1CAN081001

SUBJECT: License Amendment Request  
Technical Specification Change Associated with Main Feedwater Isolation  
Valves  
Arkansas Nuclear One, Unit 1  
Docket No. 50-313  
License No. DPR-51

**Analysis of Proposed Technical Specification Change**

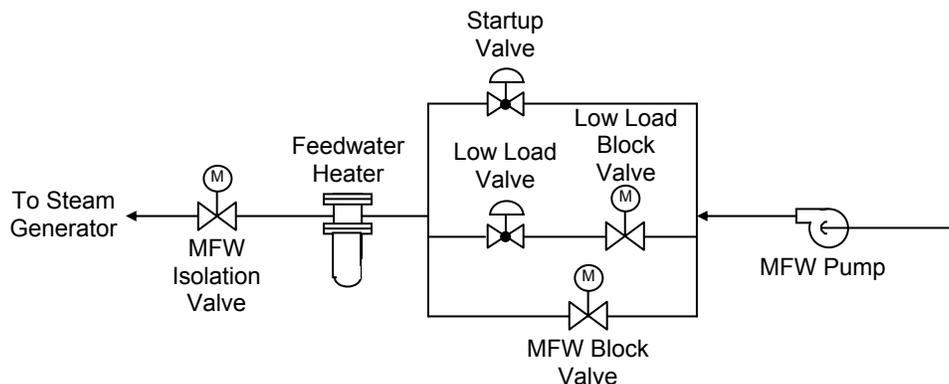
At lower power levels, steam generator (SG) level is maintained through modulation of the Startup and Low Load Feedwater Control Valves (see simplified drawing on following page). The control valves are sequenced in operation so that the startup valve opens first, followed by the low load valve. Differential pressure across the control valves is maintained through modulation of MFW pump speed.

When feedwater demand increases to approximately 50%, the MFW block valve opens, the Startup and Low Load valve demands are held constant, and the MFW pump transfers from controlling valve differential pressure to directly controlling MFW flow. This sequence is reversed for power reductions except that the block valve closes at 45% feedwater demand.

To ensure feedwater is isolated to the SG following a Main Steam Line Break (MSLB), a predetermined pressure set-point associated with a lowering SG pressure triggers an automatic Main Steam Line Isolation signal or “MSLI” which is initiated from the Emergency Feedwater Initiation and Control (EFIC) system. The MSLI signal closes the downstream MFW Isolation Valve (MFIV). As a backup, the MSLI signal, in combination with the reactor trip signal, closes the Startup Control Valves, Low Load Control Valves, and Main Feedwater Block Valves. This backup feature functions when the associated valve controllers are in automatic and the Rapid Feedwater Reduction (RFR) signal is not bypassed.
